NOTICE OF ADDENDUM ADDENDUM 1

CONTRACT NO. 7757 - FIRE STATION 9 – ROOF REPLACEMENT

SP-9KB

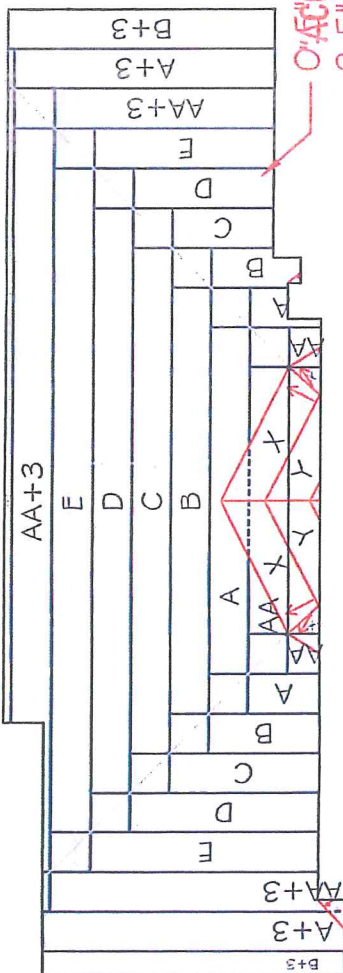
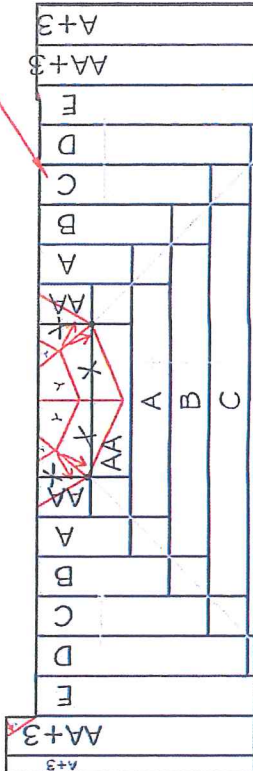
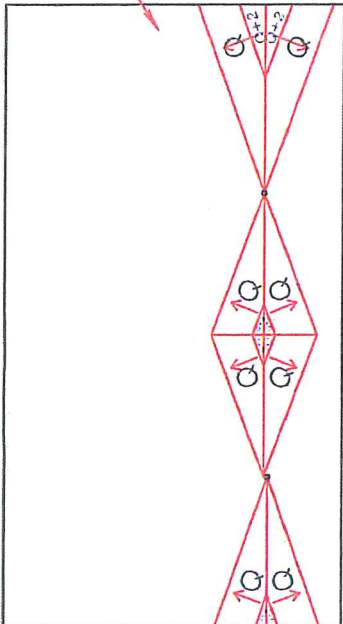
- A. See revised Spec Products SP-9KB tapered insulation drawing dated 7/12/2016.
- B. See additional perimeter dimensioning and detail associated with Firestone detail PRE-6A and PRE-6ADS. Note that the existing roof edge metal is to remain in place and note the addition of the fire treated wood blocking required at the roof edge detail to allow for the tapered roof insulation.
- C. Add new basket covers to the existing roof drains.

Kurtwell
FIRESTONE BLDG. PROB.
1/8" per Ft Acceptable
For this job - Any Areas
That Pond water must
use 3" AS. TAPER + 5" AS.
Flashing seam STRIP-IN
Structural Slope Detail
(2) Layers of 2.6"
